ENCLOSURE  
TECHNICAL EVALUATION REPORT

A REVIEW OF THE WESTINGHOUSE OWNERS' GROUP TECHNICAL  
SPECIFICATION RELAXATION ANALYSIS FOR THE ENGINEERED  
FEATURES ACTUATION SYSTEM

September 1988

Risk Evaluation Group  
Department of Nuclear Energy  
Brookhaven National Laboratory  
Upton, NY 11973

Figure 3.1. Distribution of 48 safety feature actuation signal unavailabilities for solid state and relay systems. (Only signals with identical logic and permissives are considered.)

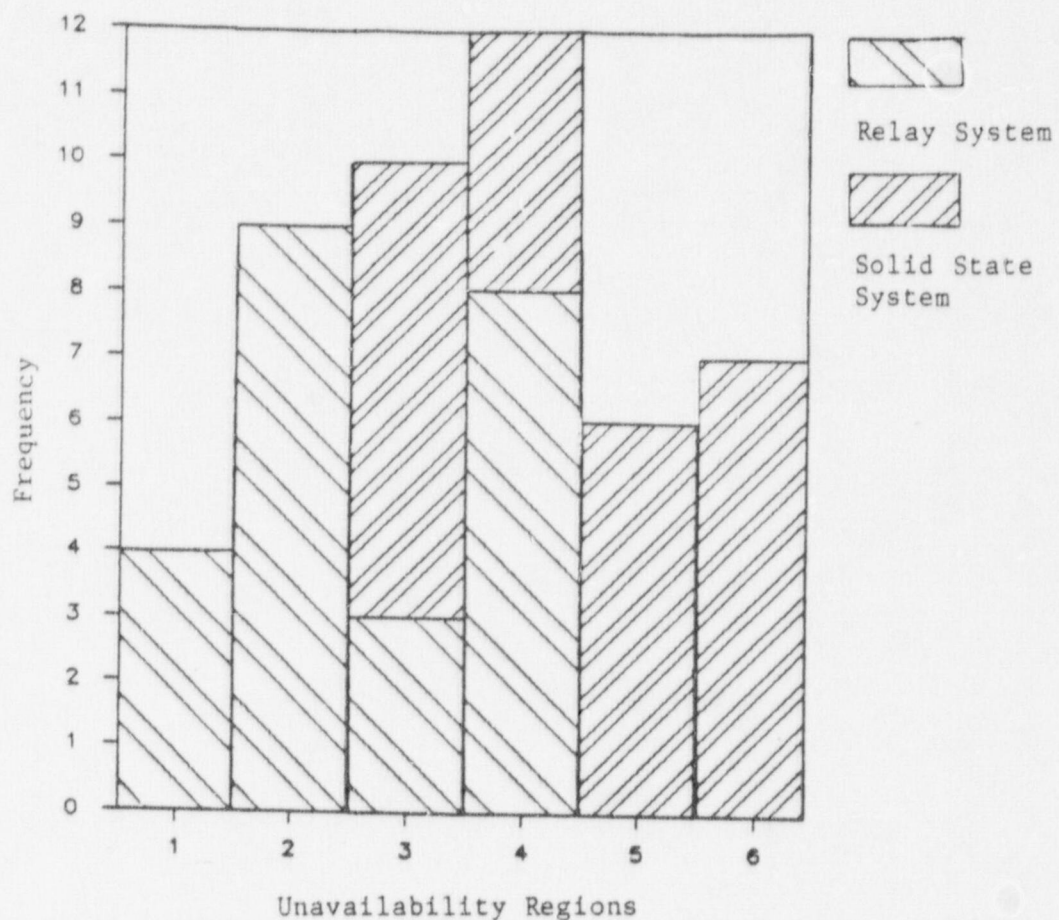
(Figure 3.1 shows the frequency distributions of 24 solid state and 24 relay signal unavailabilities selected in both cases with identical logic requirements and permissives. The distributions were compiled by BNL from WOG data to see the concentrations and spreads of these unavailabilities. The figure shows that the signal unavailabilities of the solid state system are consistently higher than those of the relay system. The distributions relate to the current set of surveillance parameters. Unavailability data given in the submittals shows that other sets of STI and AOT values provide similar distributions, i.e., signal unavailability data for the solid state systems envelope those obtained for the relay systems.)

Figure 5.1. Millstone Unit 3  
Support State Model

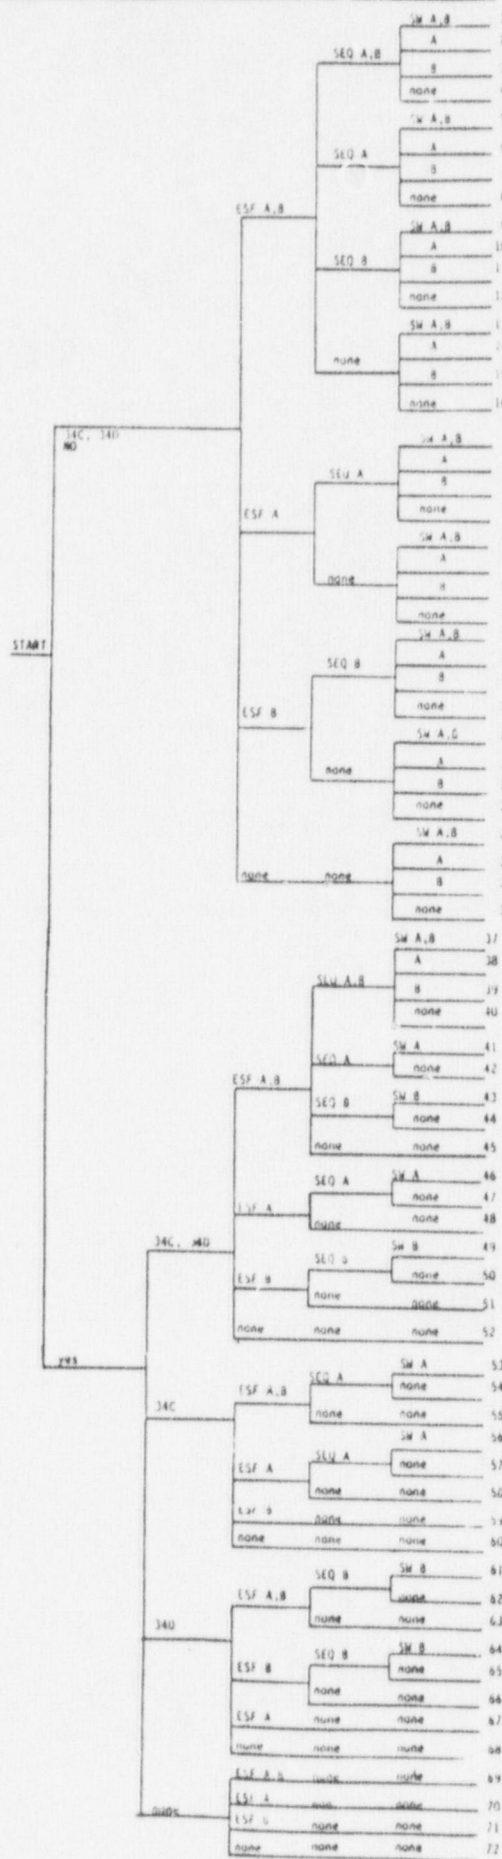
The support system model is analyzed conditional on the initiating event and the partial or total unavailability of the above support systems. Figure 5.1 shows the support state model of the Millstone 3 PSS for initiators where the ESFAS is important. The model results in 72 states, which by their impact on the frontline systems, can be reduced to 8 unique support states. The definition of these support states is given in Table 5.3.

It is clear from the model shown in Figure 5.1 that the probability of being in any particular support state will depend on the unavailabilities of the individual ESFAS trains and the whole ESFAS. Any changes in these unavailabilities will impact the state probabilities.
